2016 example of gaps in flow data: Steamboat Slough

SHR-389

Questions after review of DWR “critical year average” graphic:

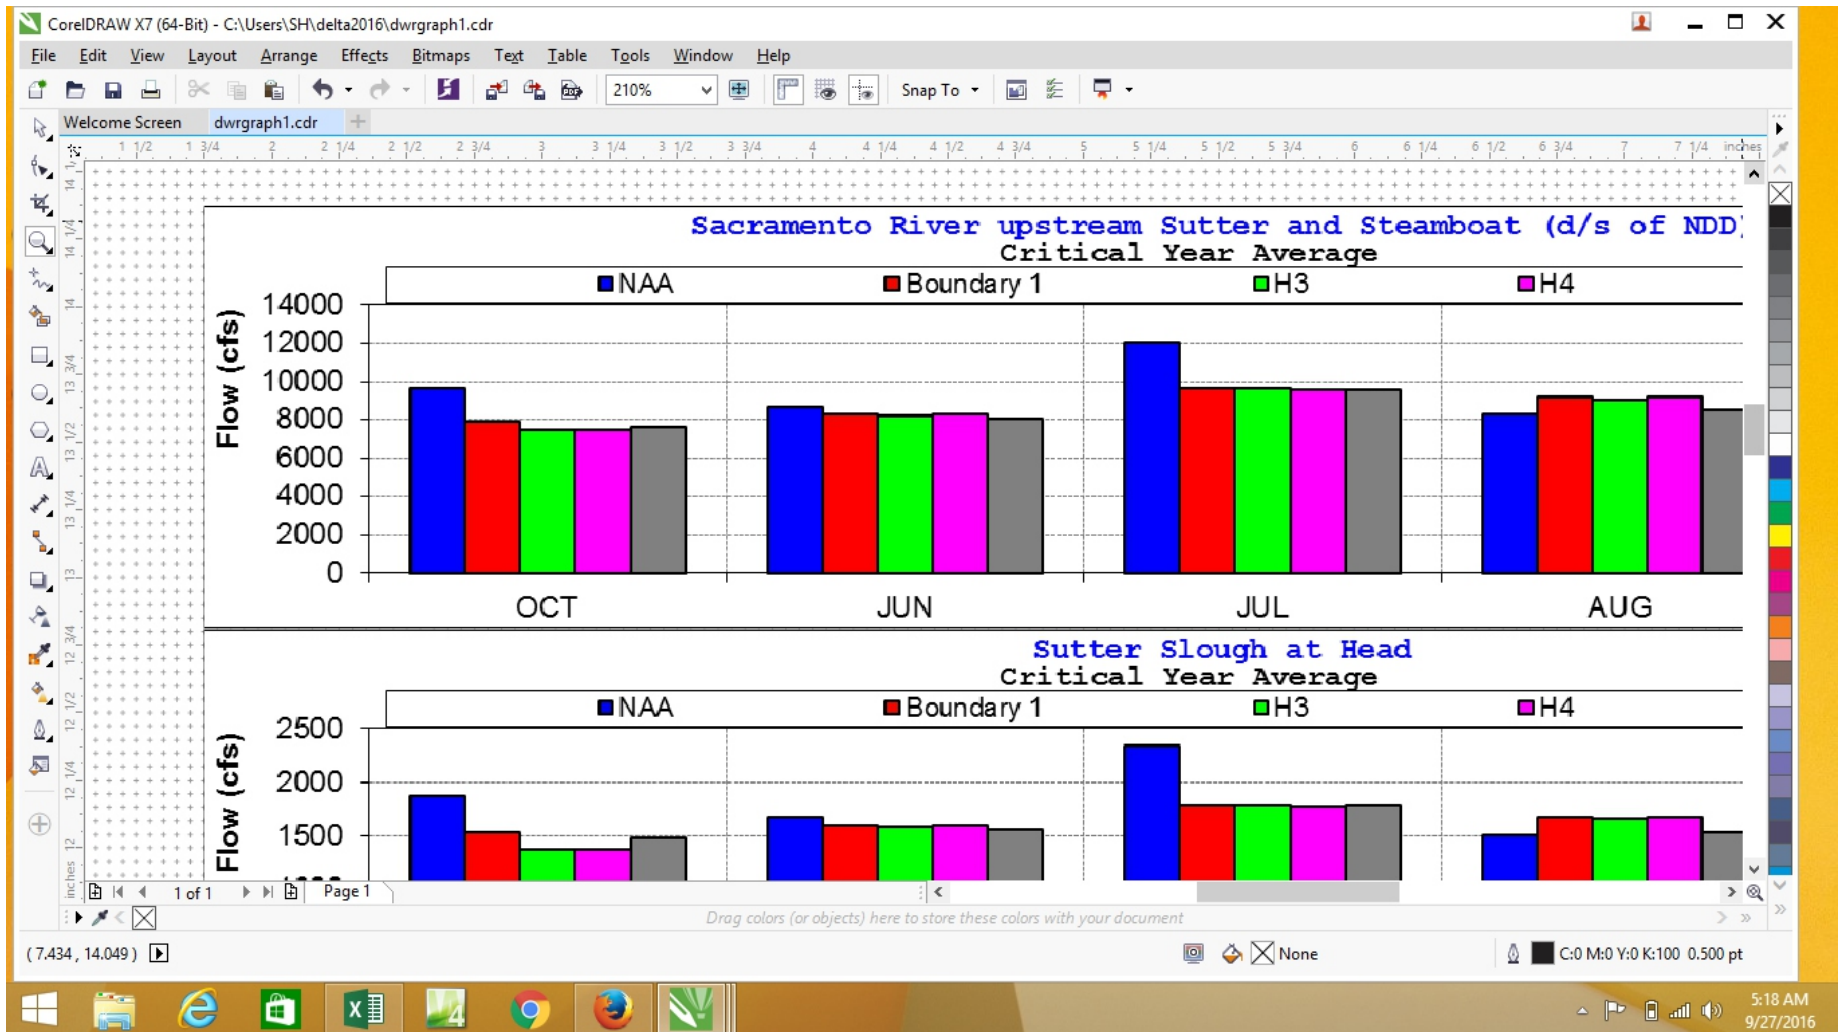
Screen print below shows how DWR graphic was imported to Corel Draw so that a grid background could be utilized to estimate the flow numbers, since DWR refused to provide the data in an excel spreadsheet or other useable form, as originally requested by SHR.

1. Note the Disclaimer on DWR graphic: “The information provided represents the monthly average flows at the locations you requested. The actual flows reflecting the effects of natural tide could be significantly different from those shown in the figures”. Please describe possible range of differences. Higher flows? Lower flows?

2. Which computer model was this based upon? Which time period? Is this similar to flows for 2015?
3. How much in-Delta use is accounted for in the flow data? If not included, why not?

4. It appears that currently, from your graphic, in September there is a monthly average flow of between 700 to 800 cfs on Steamboat Slough above the confluence with Sutter Slough. I asked for flows on lower Steamboat Slough by Snug Harbor. Have you modeled lower Steamboat Slough flow and if so, why wasn't it provided? If it wasn't modeled, how can you be sure SHR surface water rights and use of shallow aquifer for fresh drinking water won't be affected by proposed low flows? Have you reviewed the impacts to area drinking water wells from the last 5 years of excessively low flows in the North Delta?

5. Is 700 cfs average flow sufficient to maintain fresh surface and/or aquifer drinking water along Steamboat Slough, in your opinion as an expert in flow modeling? On Steamboat Slough at the lower gage location? Do you know of a better model that could provide this kind of detailed data?
